CITY OF ST. PETERSBURG, FLORIDA
PLANNING AND DEVELOPMENT SERVICES DEPARTMENT
URBAN PLANNING AND HISTORIC PRESERVATION DIVISION

STAFF REPORT

Community Planning and Preservation Commission Certificate of Appropriateness and Variance Request

AGENDA ITEM: CITY FILE NO.: COA 20-90200098/Variance 20-54000060

ENLARGED GARAGE PLAN 1/4" = 1'-0"

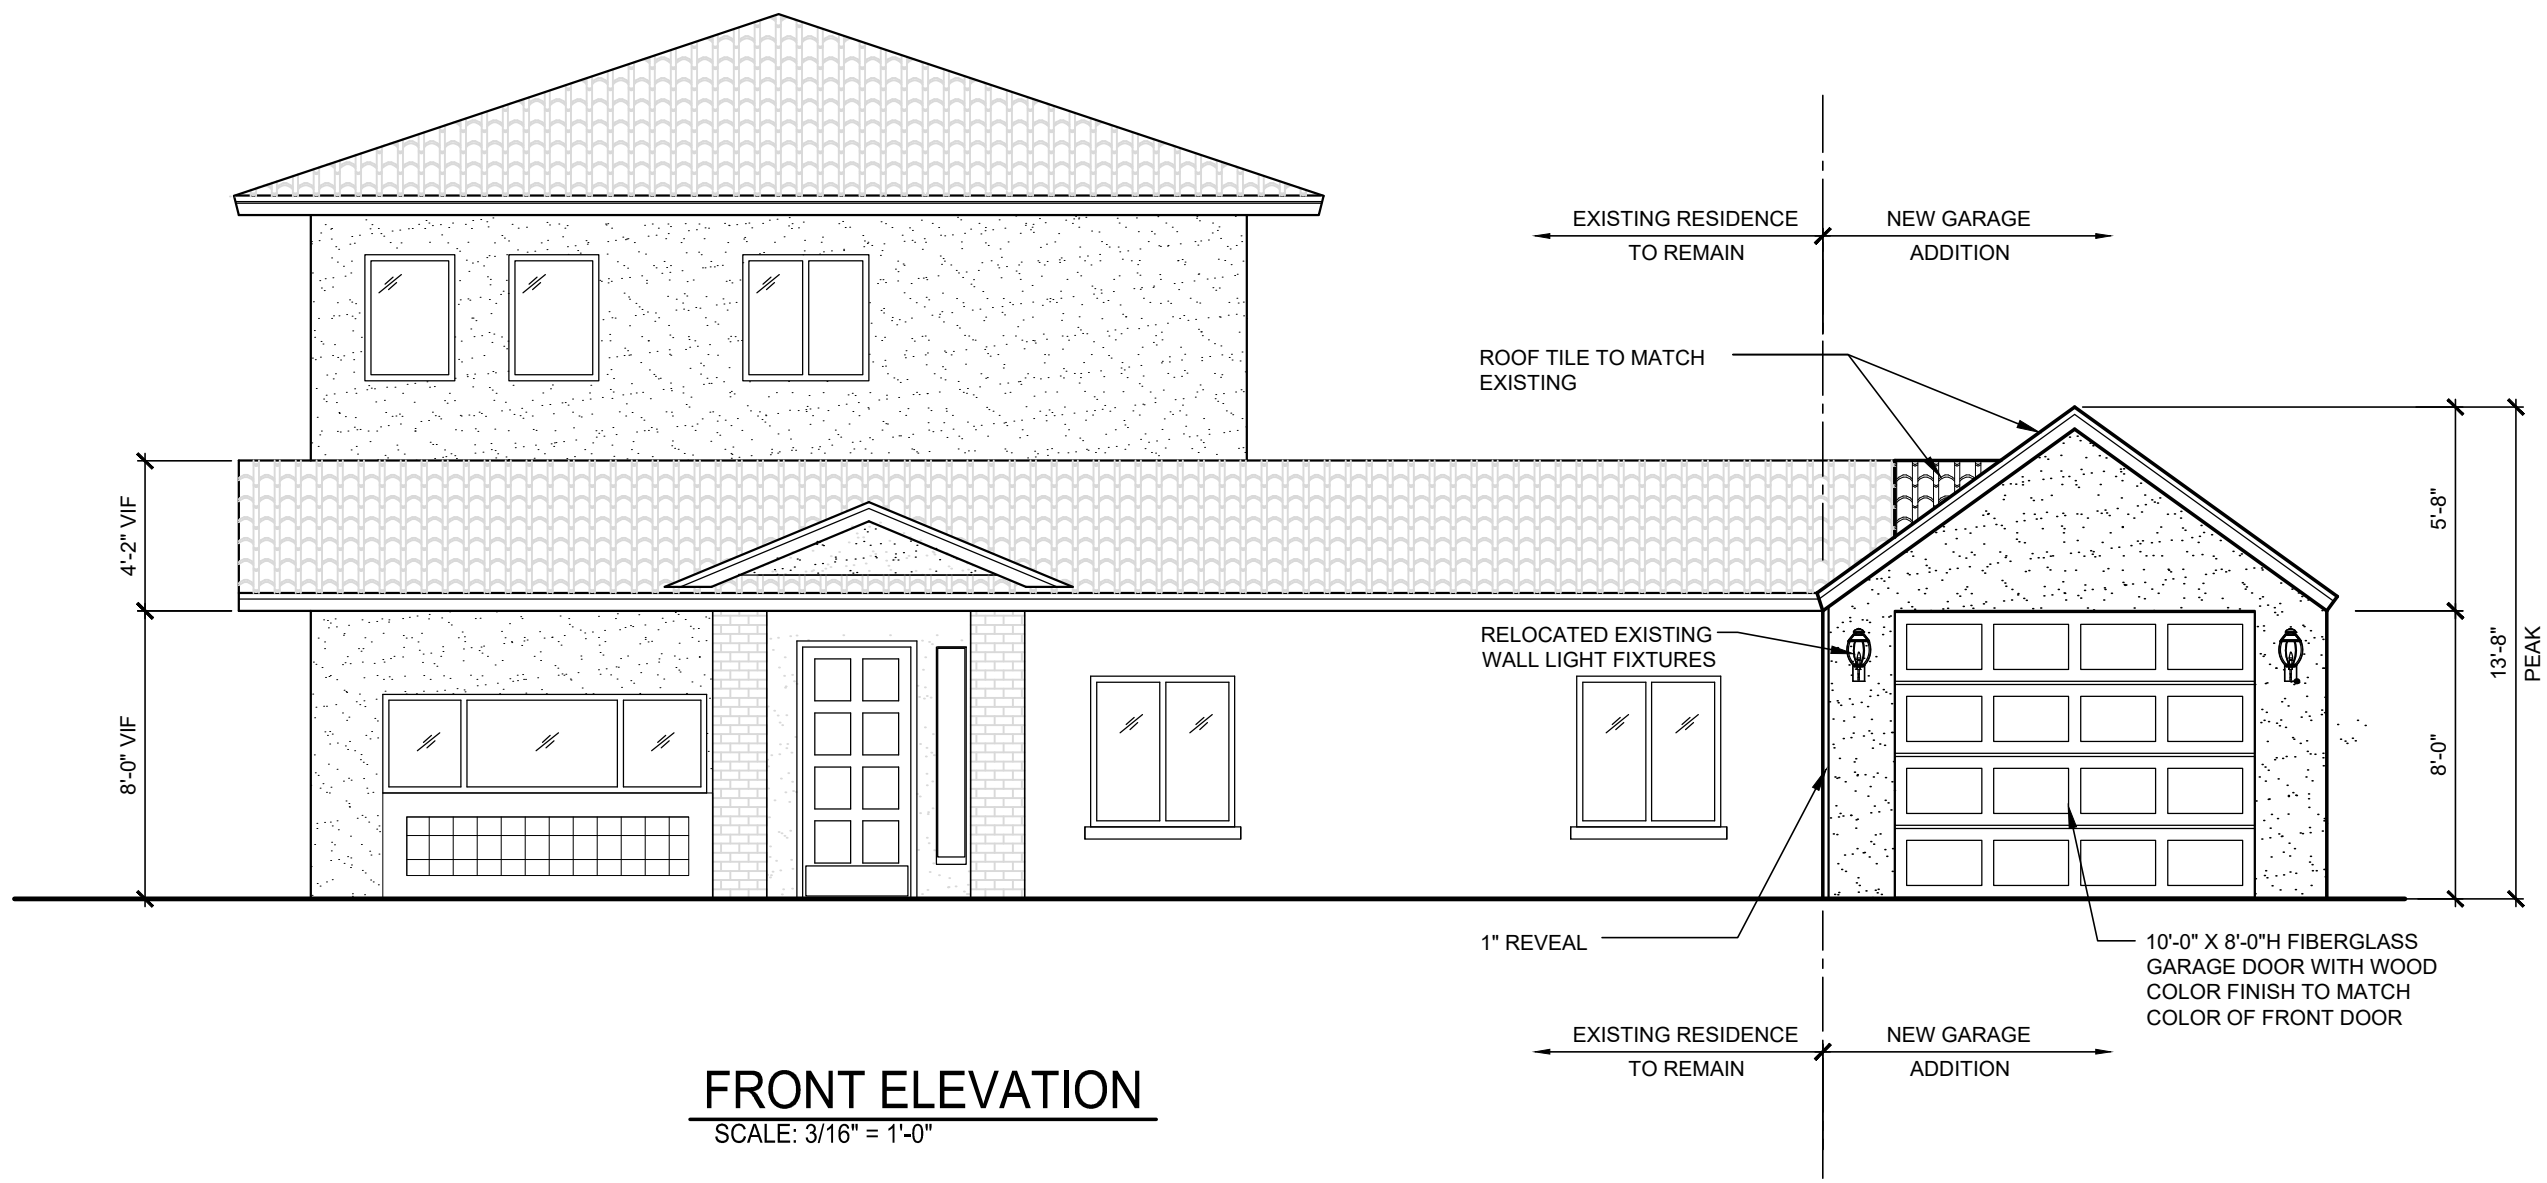
The proposed front-gabled roof of the garage addition will be slightly higher than the property's original roofline, which is not recommended. However, the applicant has decreased this height significantly from the original proposal in

Consistent with the Planning and Zoning recommendations and public comment, staff recommends that a garage addition at the subject property should be set back from the existing façade. This would accomplish the goals of adding articulation to the massing, as well as adhering to the hierarchy in which garages are visually subordinate to primary residences.

Staff has suggested that creating a small degree of articulation between the existing residence and proposed garage addition would create a more harmonious appearance than the extension of a straight façade line. Due to space constraints created by the irregular shape of the parcel and existing fenestration, the applicant has stated that a recessed garage is not possible in this location.

Generally consistent After considering staff feedback, the applicant lowered the proposed front gable's pitch to be lower than the adjacent detached garage at 13 feet, 8 inches. Ideally the pitch of the roof's addition should match that of the original

Staff does have concerns about the visual horizontality that will be created by the addition's creation of an unbroken façade line.

Inconsistent As noted above, the broad horizontal massing of the subject property is already fairly out of context for the subject district, and the proposal would serve to increase this impact by creating a façade with a total width of approximately 56 feet.

Generally consistent The proposed picture window at rear will not be visible from right of way. The plans show a fixed window approximately 10 feet wide at the rear of the addition, but information was not provided regarding its height or vertical placement. The proposed single-car panel garage door is similar to that found on other non-contributing resources and as an alteration on contributing resources.

Inconsistent The proposed flatness of the façade will enhance an existing incompatibility within the subject district.

Inconsistent The proposed roofline

Consistent A new gate is proposed in the side setback. Information on its material or design is not included but it should be wood or metal to comply with St. Petersburg's Design Guidelines for Historic Properties.

Inconsistent Proposed increases an existing inconsistency by extending the subject property's façade to create an even wider flush, horizontal plane. Staff suggests that a setback between the existing façade and proposed garage addition will mitigate the expansion's visual impact.

Based on a determination of general consistency with Chapter 16, City Code of Ordinances, staff recommends that the Community Planning and Preservation Commission **APPROVE WITH CONDITIONS** the Certificate of Appropriateness request for the addition to the property at 125 23rd Ave. NE subject to the following conditions:

1. The garage addition shall be set back between 2 and 5 feet from the primary façade line of the residence;
2. The roof form of the addition shall feature a pitch compatible with the roof forms at the primary residence. The revised roof form is to be approved administratively with Commission review upon request of staff or the applicant;

3. The proposed gate shall be constructed of wood or metal material;
4. Details of the proposed windows and door at the rear and side of the garage addition shall be reviewed and approved administratively. The windows shall be recessed in the wall plane approximately 2- to 3 inches and feature a sill to provide consistency with windows at the primary residence;
